DEVELOPMENT REVIEW COMMITTEE (DRC) COMMENT REPORT

**Project Name: 5512 NW 10th Terrace, LLC et al / Adonel
Concrete**

Case Number: R15036

**Request: Site Plan Level III Review: Conditional Use for
Expansion of Concrete Plant in Industrial Zoning**

Project No. 215612276 Scale
Drawing No. C-03 Sheet of 13 Issue/Revision

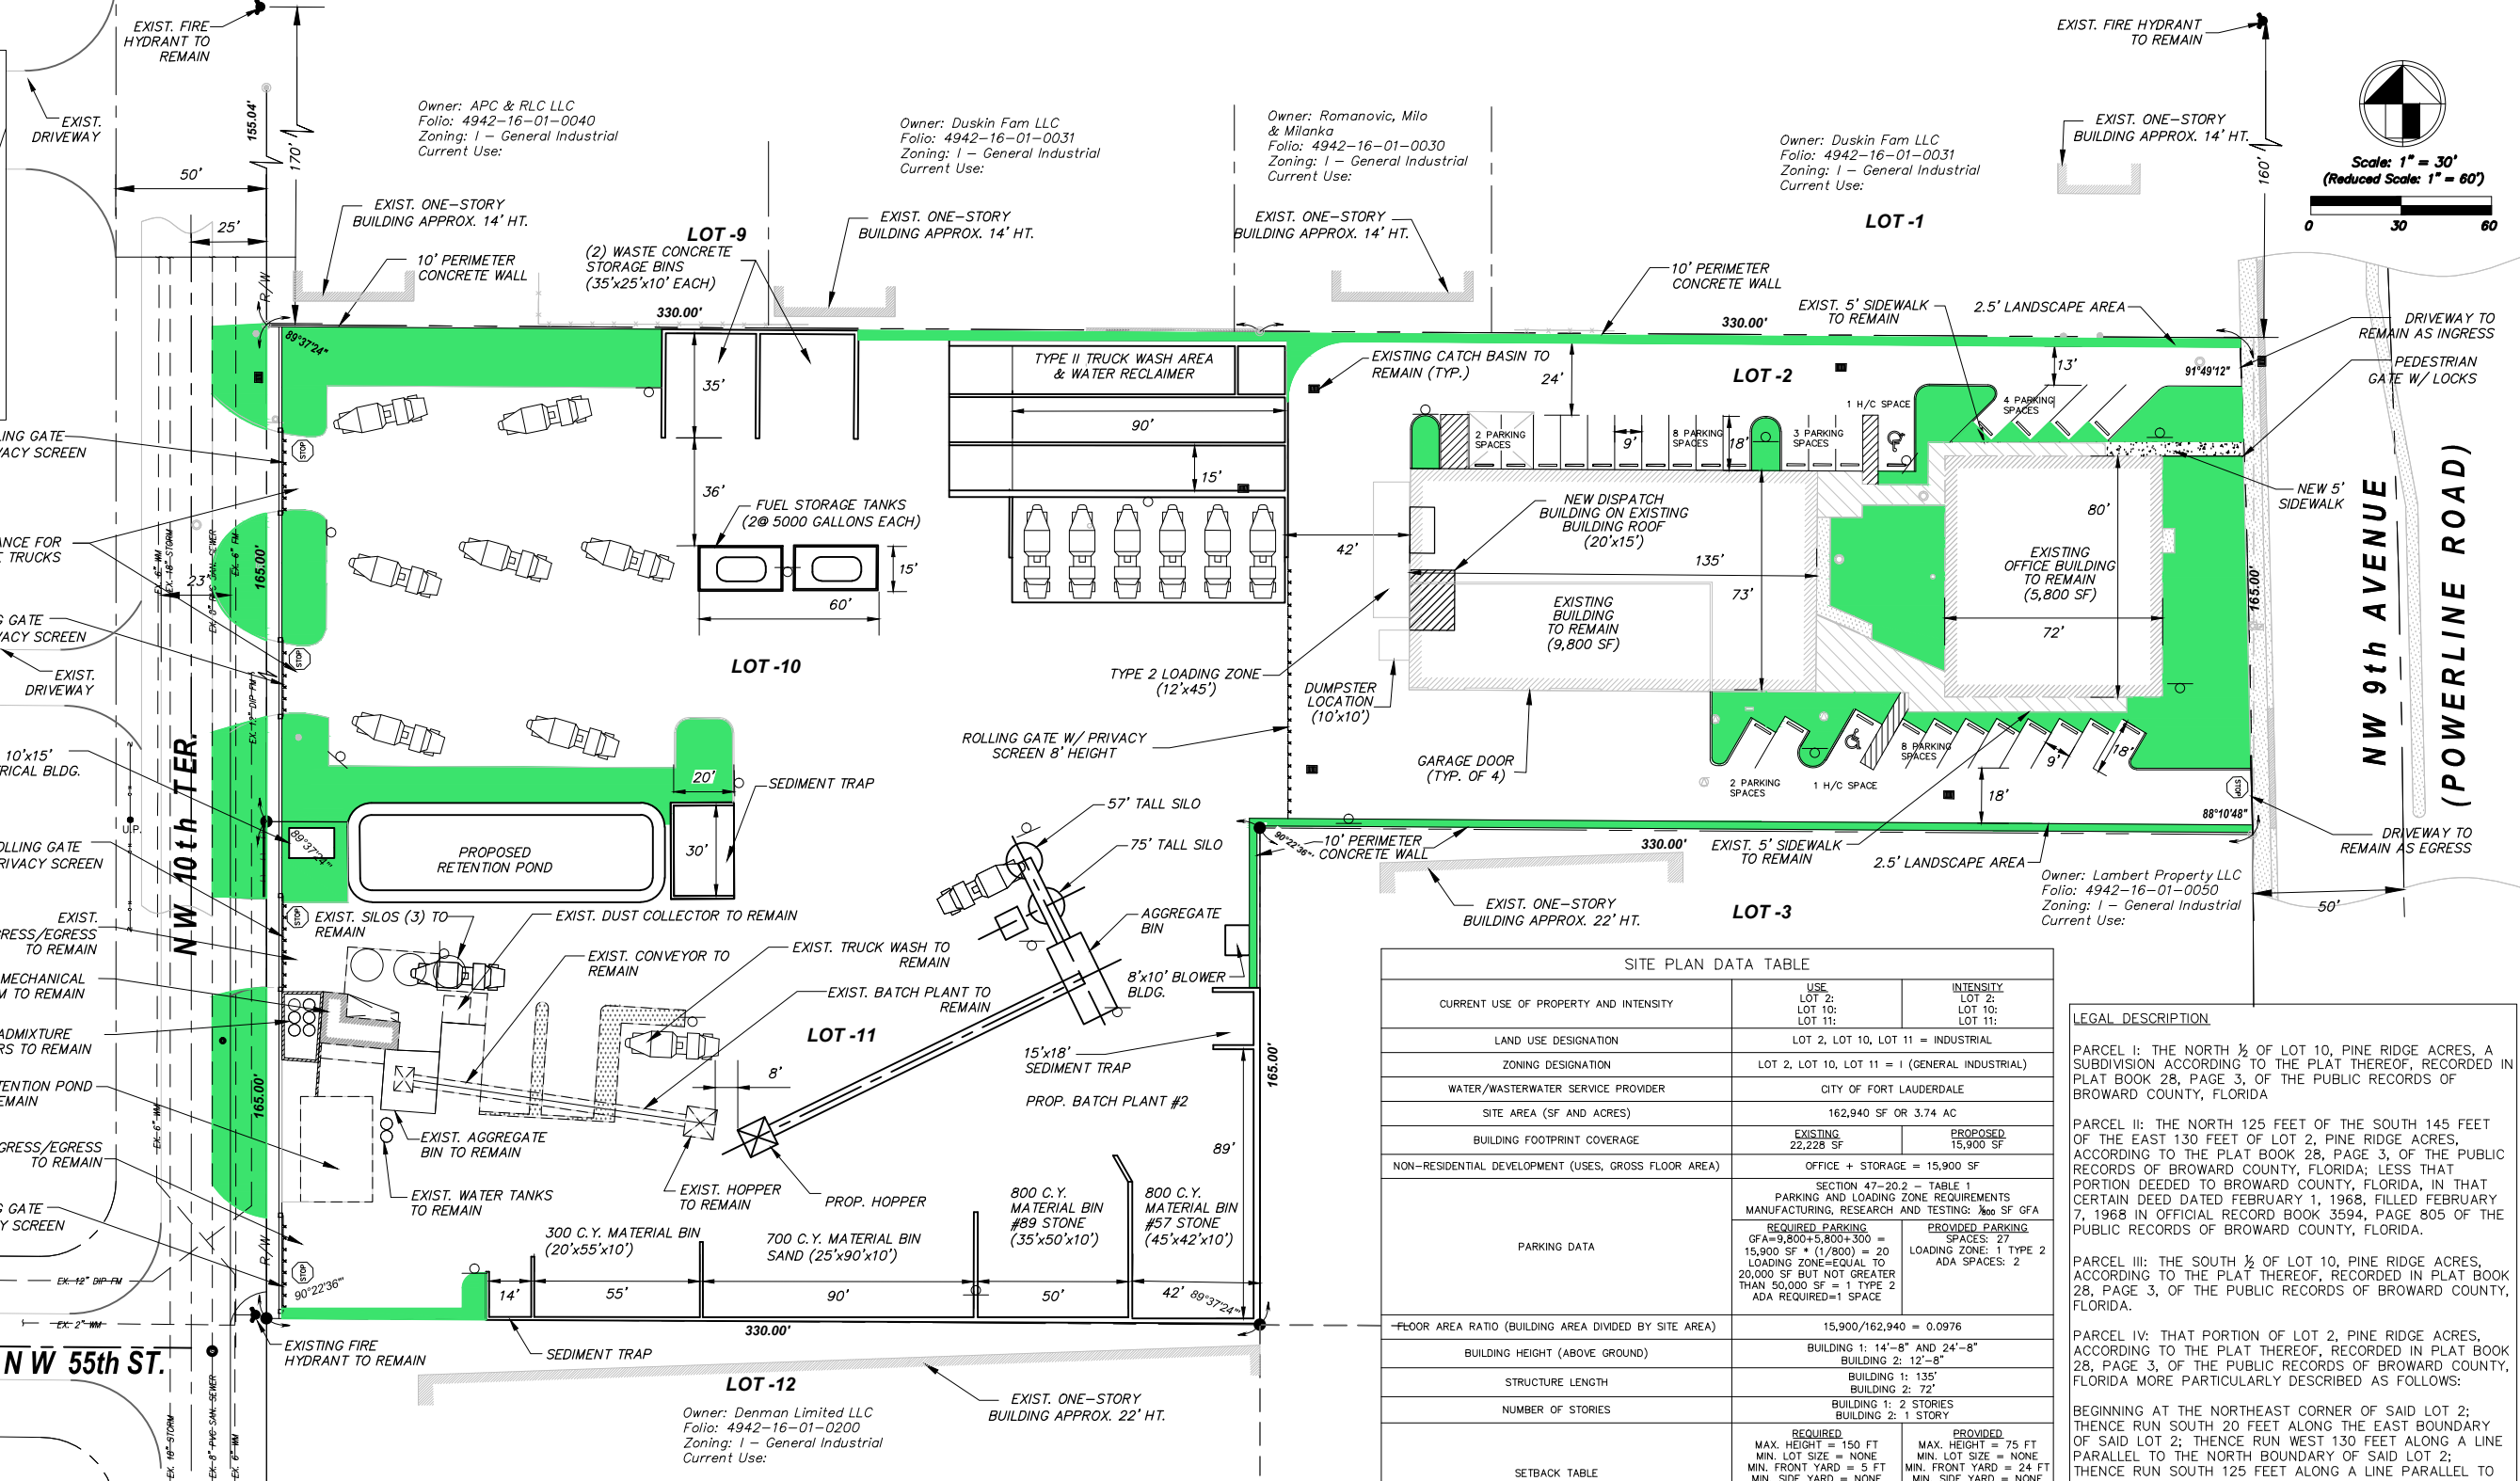
9. Proposed Site Plan (Sheet C-03) – Show the existing swinging gates located near the N.W. 9th Avenue access driveways to/from the existing parking lot. Please be advised that per ULDR Section 47-20.5.C.6, provide and dimension the minimum stacking distance required for all driveway ingress to and egress from the site - a minimum of 12' wide by 22' long area for each vehicle to be accommodated within the stacking area.

10. Label width of all Rolling Gates for this development, including the one near the middle of the property, separating the Truck Circulation Area from the Parking Area.

12. The proposed parking stall configuration shall conform to the ULDR Section 47-20.11 design criteria; in addition to the typical drive aisle and parking stall dimensions, please label the proposed parking stall angles.

- 10) On the site plan, please provide one-way only signs and arrows on the pavement that show one-way circulation around the principal structure.

1 BLDG. 1 EAST ELEVATION
1/8"=1'-0"

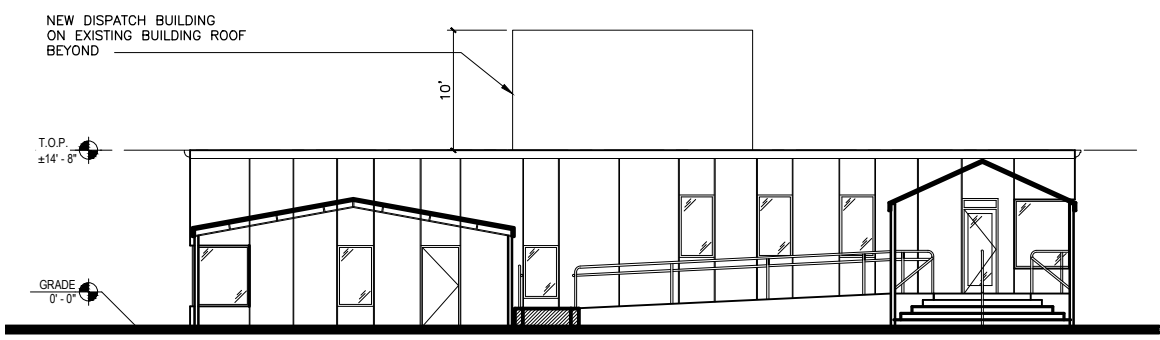
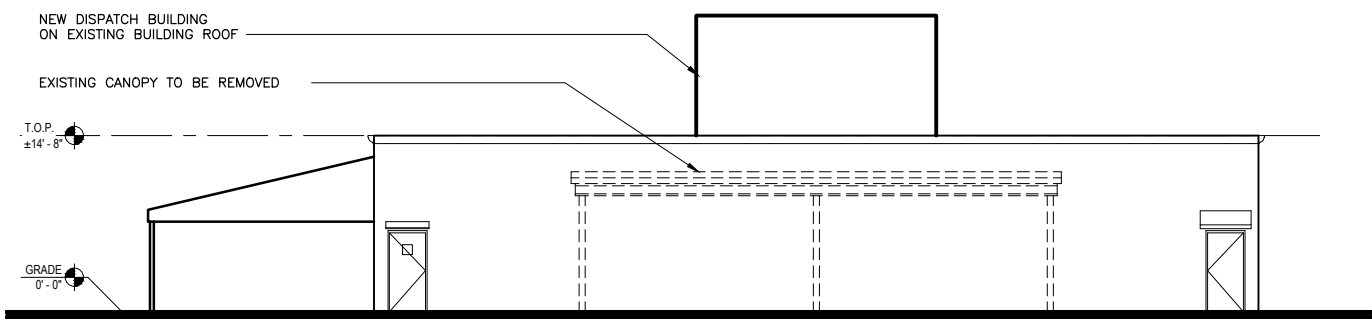
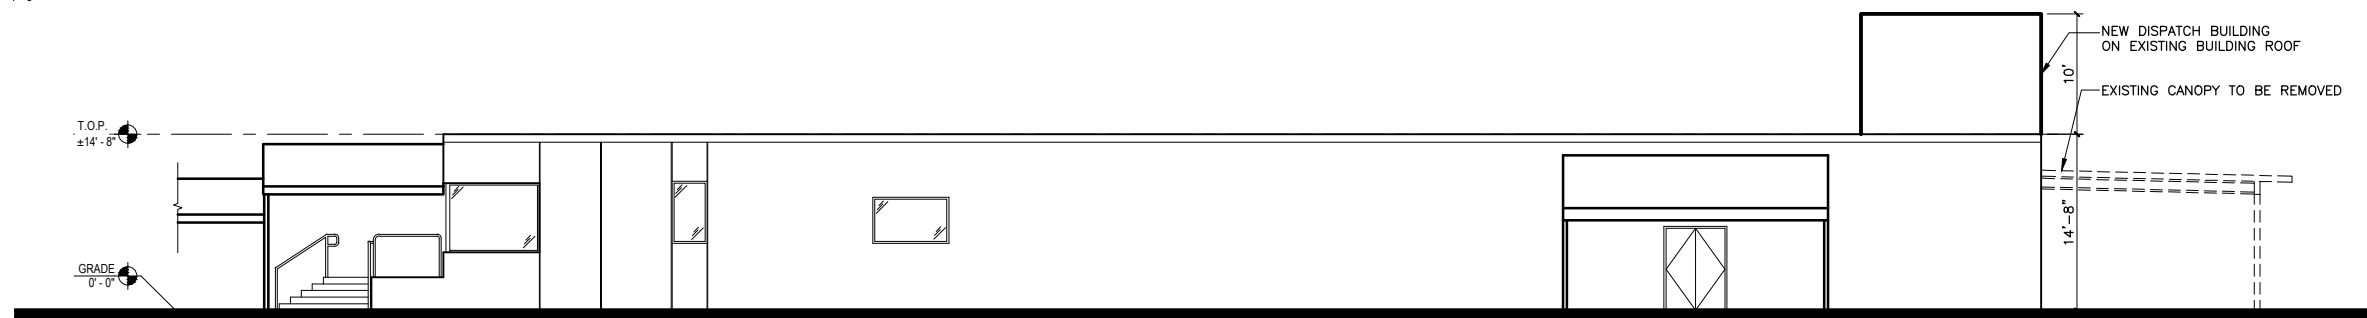
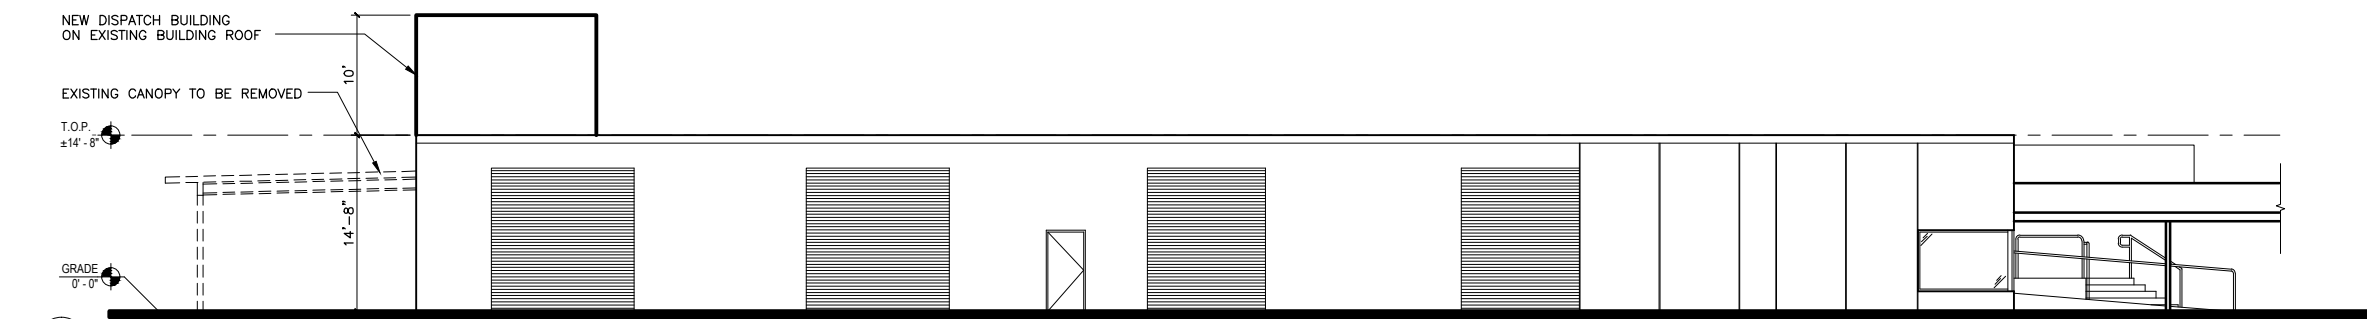
- 8) On NW 9th Avenue, please consider a more active building façade, such as adding fenestration by incorporating windows, etcetera and/or a façade treatment that improves the aesthetic appearance and overall building composition and articulation.
